Access Compliance Report

Public Rights-of-Way

Intersection ID: 22694	Main Street: CAMILLA_DR	Cross Street: FERNBANK_DR	Location: NE
ADA ID: 63D00B4F1458	Ramp Type: Perp	Initial Pass/Fail: Fail	Overall Compliance: No
		Severity Score: 25

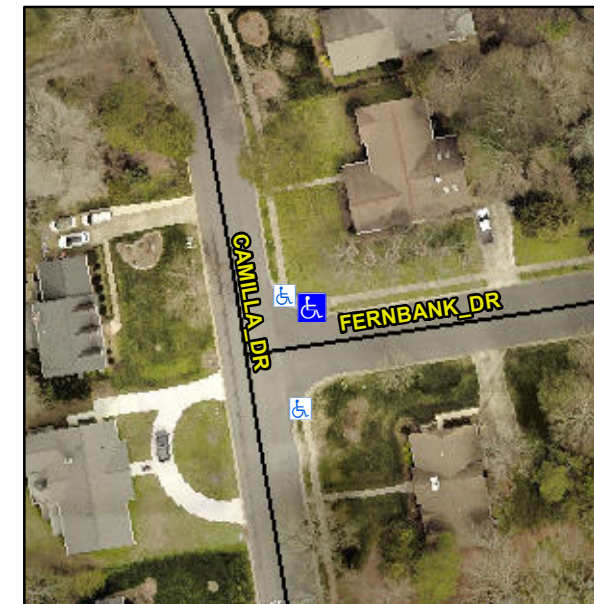
Not Found, R304.5.3

Compliance	Description	Data	Compliance	Description	Data
N/A	Ramp Length (in)	74.0	Yes	Ramp Slope (%)	5.1
Yes	Ramp Width (in)	48.0	No	Ramp XSlope (%)	7.3
N/A	Flare Type LT	N/A	N/A	Flare Type RT	N/A
N/A	Flare Slope LT (%)	N/A	N/A	Flare Slope RT (%)	N/A
N/A	Flare Traversable LT?	N/A	N/A	Flare Traversable RT?	N/A
N/A	Landing Length (in)	N/A	N/A	DWS Provided?	N/A
N/A	Landing Width (in)	N/A	N/A	DWS Contrast?	N/A
N/A	Landing Slope (%)	N/A	N/A	DWS Length (in)	N/A
N/A	Landing X Slope (%)	N/A	N/A	DWS Full Width?	N/A
N/A	Landing Curb? (Y/N)	N/A	N/A	DWS Offset (in)	N/A
N/A	Shared Landing?	N/A			
N/A	Gutter Ponding?	N/A	N/A	Gutter Slope (%)	N/A
N/A	Gutter Lip Ht (in)	N/A	N/A	Gutter X Slope (%)	N/A
N/A	Painted X Walk1?	No	N/A	Painted X Walk2?	N/A
	X Walk 1 Direction	To S		X Walk 2 Direction	N/A
N/A	X Walk 1 Width (in)	N/A	N/A	X Walk 2 Width (in)	N/A
	X Walk 1 Slope (%)	1.2		X Walk 2 Slope (%)	N/A
	X Walk 1 X Slope (%)	5.6		X Walk 2 X Slope (%)	N/A

Remove & Replace Entire Ramp.
